DEVELOPMENT/ PLAN REVIEW APPLICATION

RE: Request for Amendment to Site Development Plan for Subdivision

15EPC-40008 - Amendment to Sector Development Plan for Subdivision

Re Project # 1000596 15EPC-40008 Amendment for Site Development Plan for Subdivision

Exposed hospital generator above southeast corner of Martineztown Park. Generator should be hidden by a wall to block noise and visual impairment.

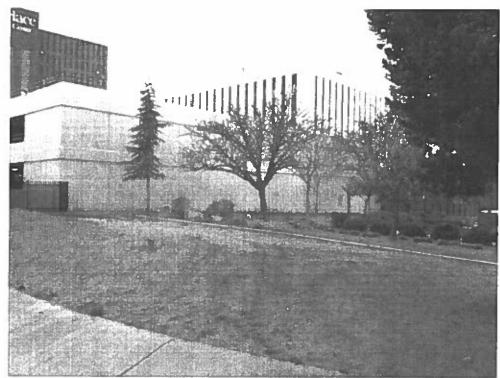
High St slope area. Landscaping of the southeast corner of Martineztown Park would include measures to control erosion.
